TOWN OF YARMOUTH
200 Main Street, Yarmouth, Maine 04096
www.yarmouth.me.us

Planning Board Report
Nuance Dental at 233 Route One
Concept Plans for Building & Lot Plan & Major Site Plan
Cone Cladicals, LLC, Applicant
Map 31 Lot 25; CD4-C Route One Corridor
Prepared by Erin Zwirko, Director of Planning and Development
Report Date: June 22, 2023; Planning Board Date: June 28, 2023

Proposed Nuanca Dental Site Plan

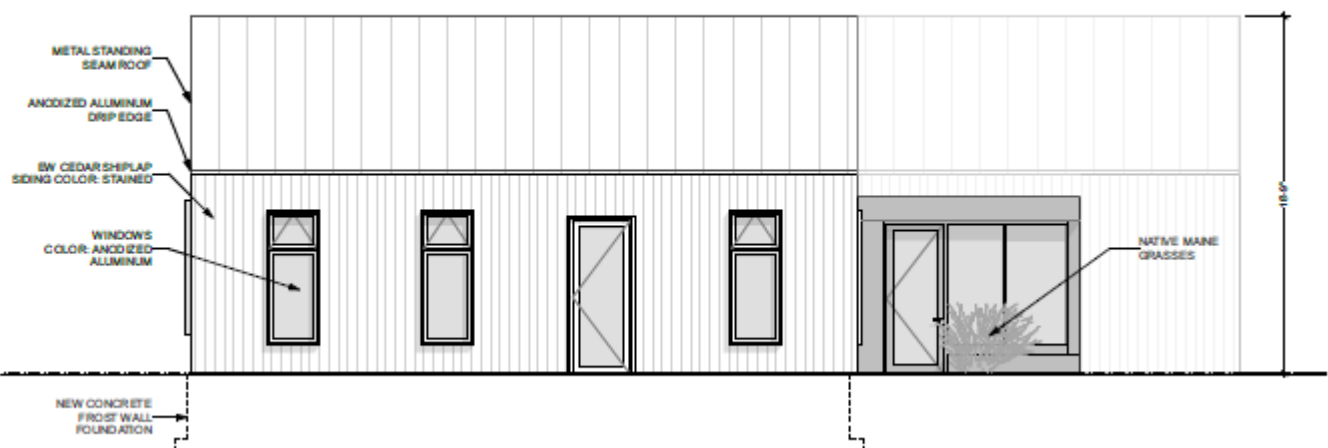
The large parking lot that supported the shuttered restaurant will be eliminated and replaced with a small 6 parking space lot. The proposed number of parking spaces is within the range of parking spaces allowed for the office use. In future filings, the applicant should identify where a bicycle rack is located, although the CBDC does not require it due to the size of the parking lot and identify the accessible route through the small parking lot to the sidewalk adjacent to the building.

- The proposed site includes a driveway that crosses the proposed sidewalk, adjacent to a large esplanade area. This driveway should ramp up to sidewalk level, using the esplanade area (which appears to be 12-15 feet wide) to ramp up to sidewalk level. This will prioritize pedestrian traffic crossing the driveway and slow cars as they enter. The long nature of the driveway means that it should be able to slope back down to meet the proposed grades near the parking lot area, if needed.

- The crosswalk/buffer area markings that are shown next to the accessible parking space should be extended to the sidewalk ramp that connects to the entrance of the building.

Route One (West) Elevation

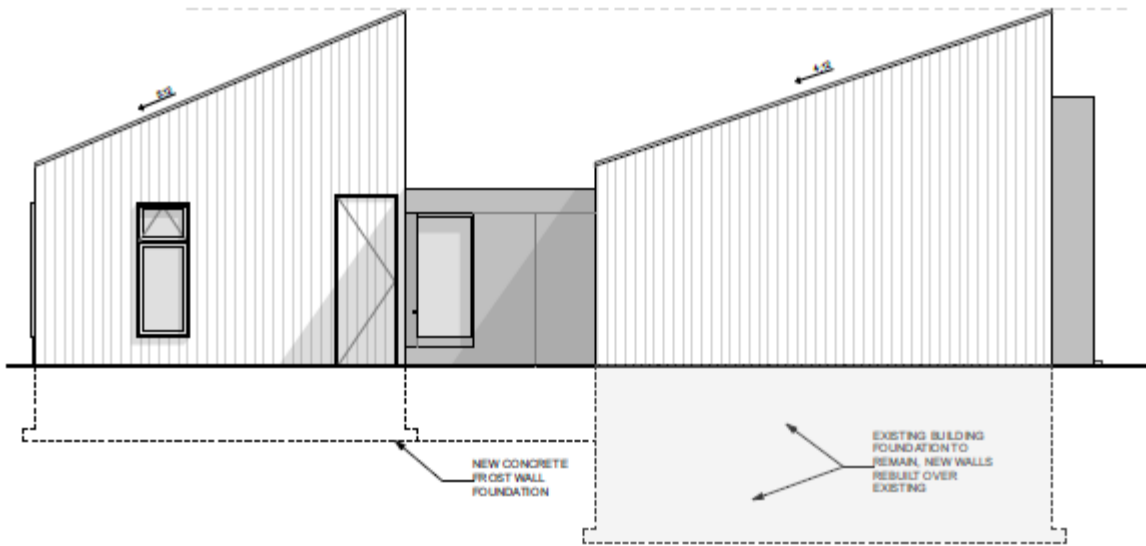
The applicant is proposing a shed roof. The applicant completed the architectural matrix and notes the advantage of the shed roof is that affords greater access to ambient, indirect light to the proposed operatories and the photography studio. The slope of the roof is 5:12 and can be approved with a waiver.

The structure is at an angle to Route 1, so that the primary façade does not run parallel to the primary frontage. The location is driven by a desire to reuse a portion of the existing structure's basement. Although more details may be needed to fully assess this request, the use of hardscape walls elongate the primary façade parallel to the primary frontage for a length of approximately 40 feet. It results in a frontage buildout of 28% and can be approved by waiver.
